Addendum 2

RFQMA24 – 5030

Glenforest Secondary School City of Mississauga

Pool Demolition

Graphic Scale	AS SHOWN	Sheet no.
Drawn	Checked	M8
RS	SS	
CAD File	Scale	AS NOTED
Date	Project No.	Revision No.
DECEMBER 2022	23-124

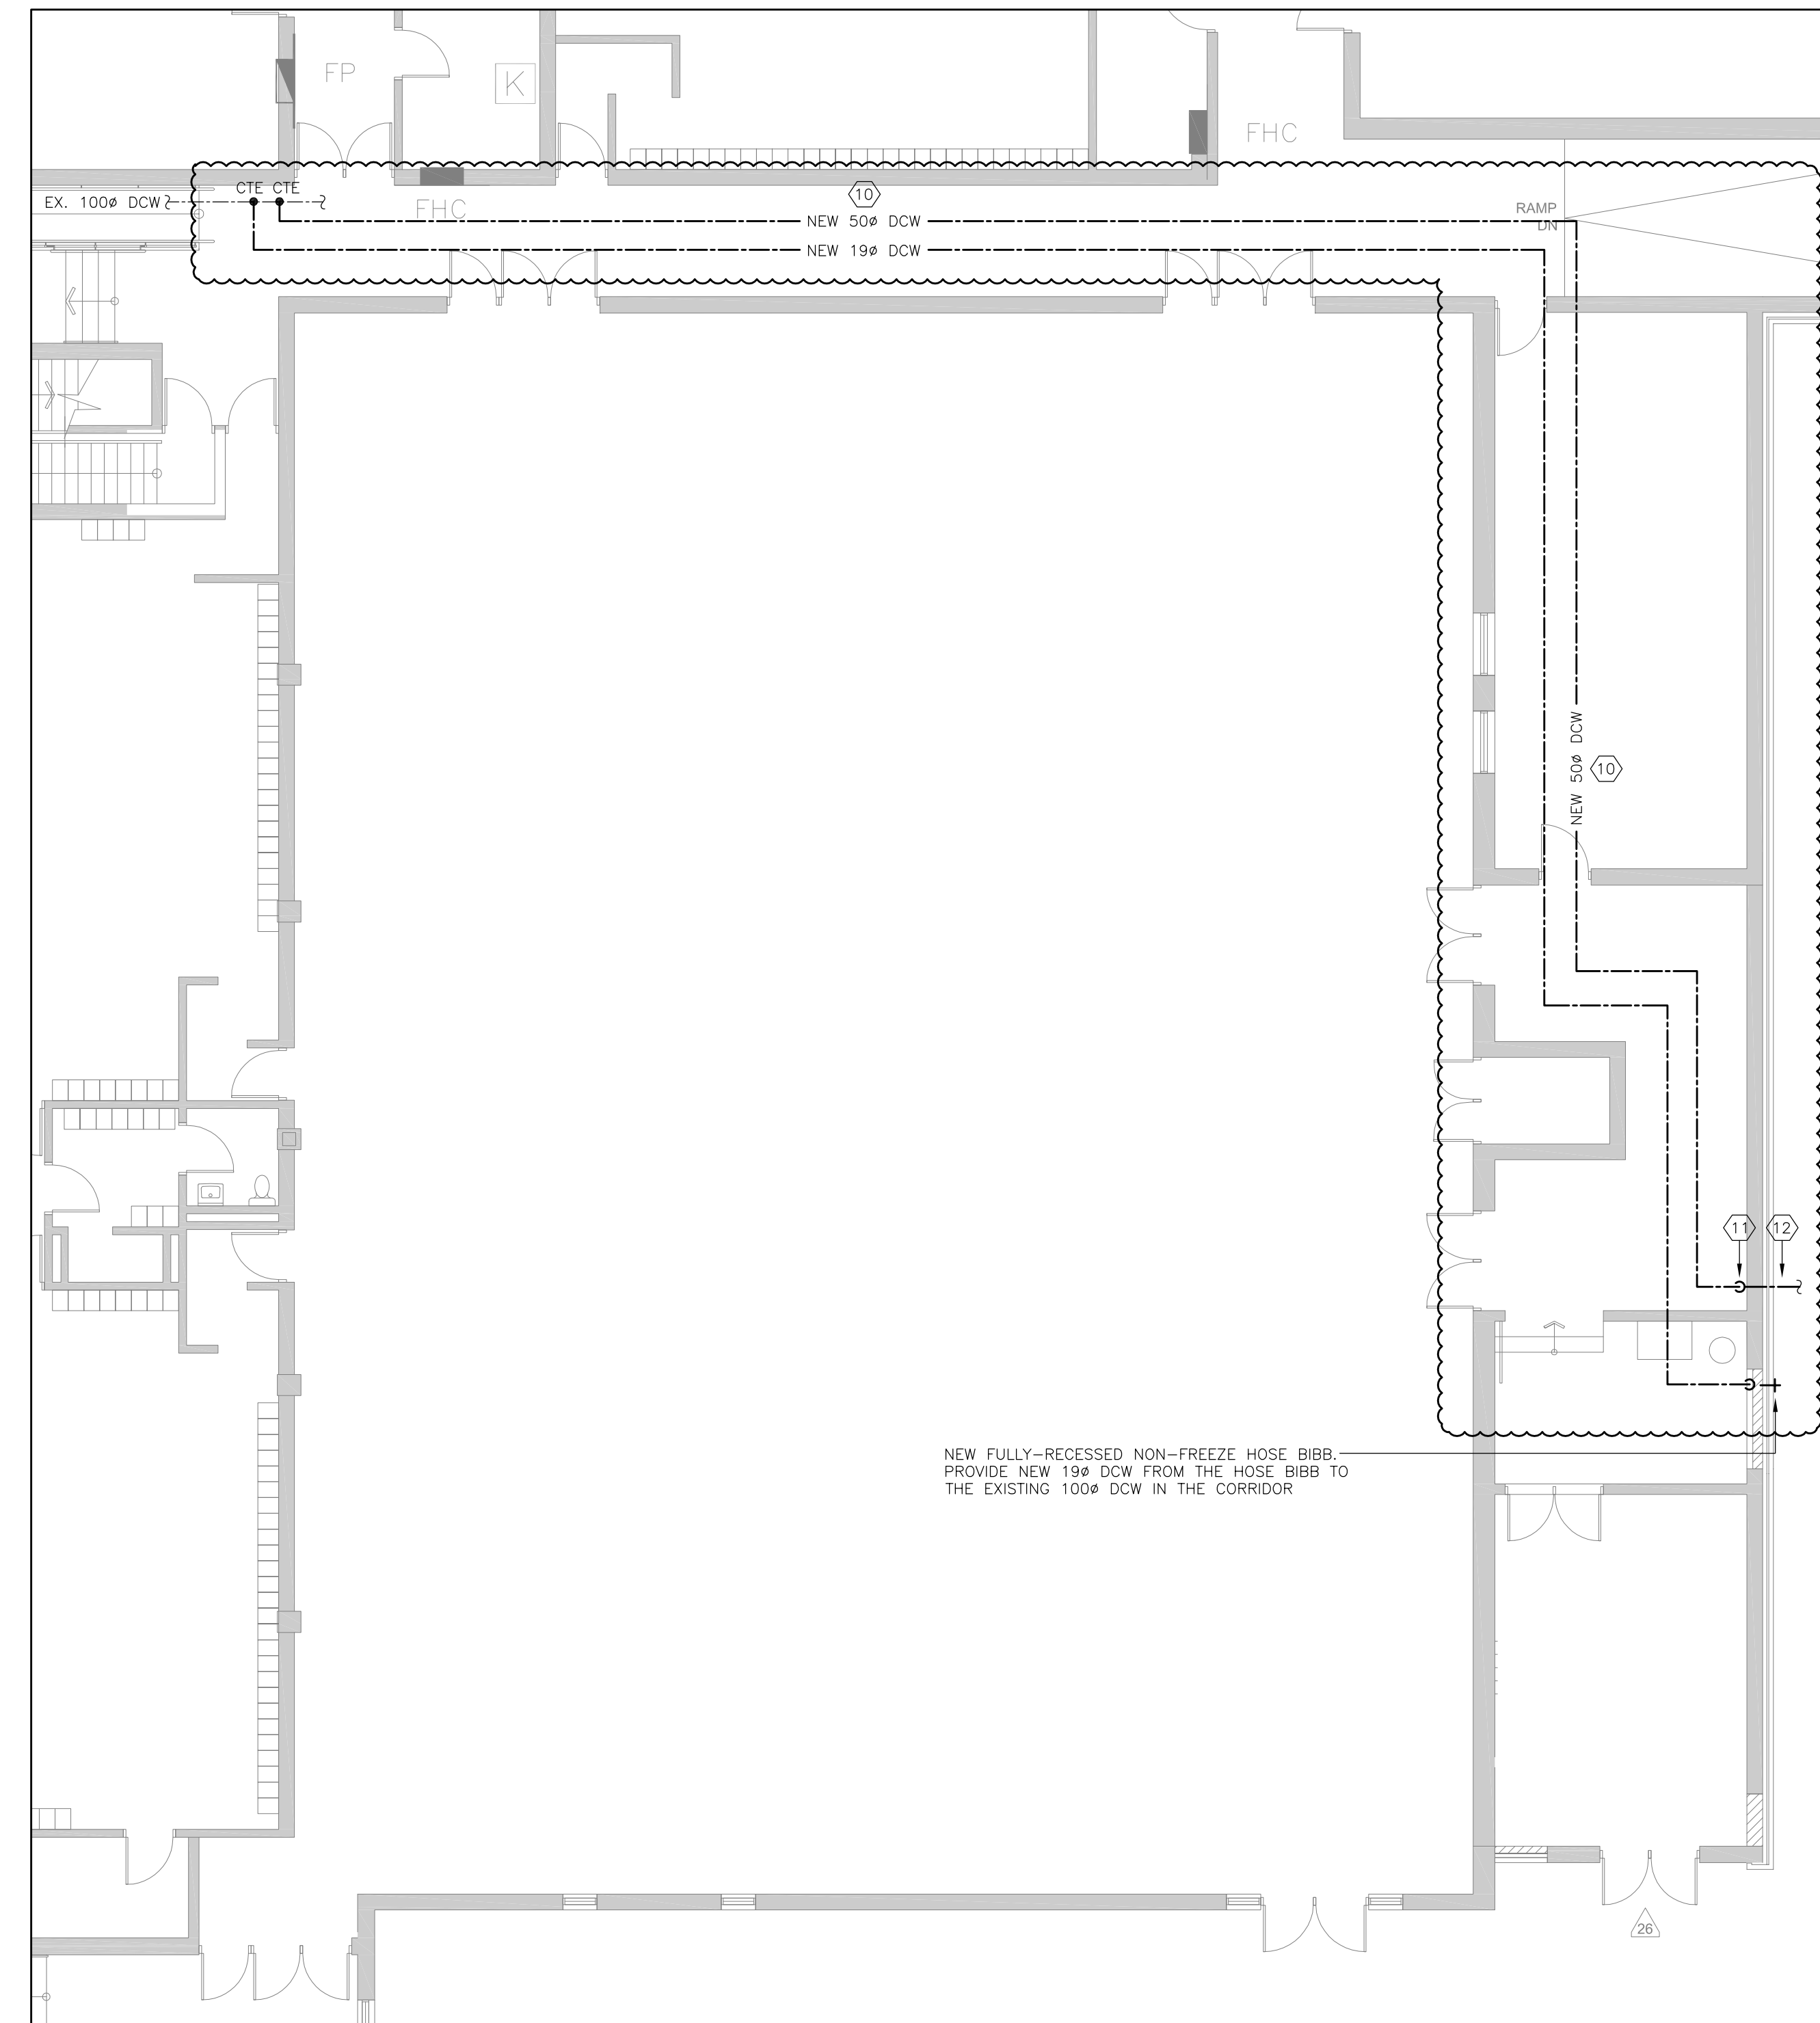
- Response 2: Refer to item 2.2 of this addendum. For temporary irrigation line requirements. GC to review and confirm existing distribution pipe sizing to confirm connections to existing supply valve. Refer to notes 10,11,12 &13 on revised 3/M8.

1. See attached re-issued Drawing with Clouded Revisions.

- 10 PROVIDE NEW 50# DCW PIPING FROM THE EXISTING 100# DCW MAIN IN THE CORRIDOR CEILING SPACE TO THE NEW IRRIGATION CONTROL BOX IN THE GYM STORAGE ROOM.

- 11 PROVIDE A NEW PRV AND BACKFLOW PREVENTER AT THE LOCATION OF THE RELOCATED IRRIGATION CONTROL BOX.

- 12 PROVIDE NEW UNDERGROUND 50# IRRIGATION LINE FROM THE GYM STORAGE ROOM AND CONNECT TO THE EXISTING UNDERGROUND IRRIGATION LINE AT THE PERIMETER OF THE EXISTING POOL BUILDING. SITE VERIFY LOCATION. APPROXIMATE LENGTH OF PIPING IS 45 METERS.
13. RELOCATION OF THE IRRIGATION CONTROL BOX, PROVISION OF POWER CONNECTION AND SUPPLY/INSTALL OF THE NEW BACKFLOW PREVENTER AND PRV AND SUPPLY/INSTALLATION OF THE NEW 50# DCW LINE TO THE NEW IRRIGATION CONTROL BOX LOCATION SHALL TAKE PLACE AT THE ONSET OF THE PROJECT. SEE ARCHITECTURAL DRAWING FOR ROUTING OF A TEMPORARY IRRIGATION LINE (ABOVE SURFACE) FOR THE DURATION OF CONSTRUCTION TO MAINTAIN CONTINUITY OF THE IRRIGATION SYSTEM DURING CONSTRUCTION. PROVIDE HEAVY-DUTY HOSE CAPABLE OF SERVICING THE IRRIGATION SYSTEM.
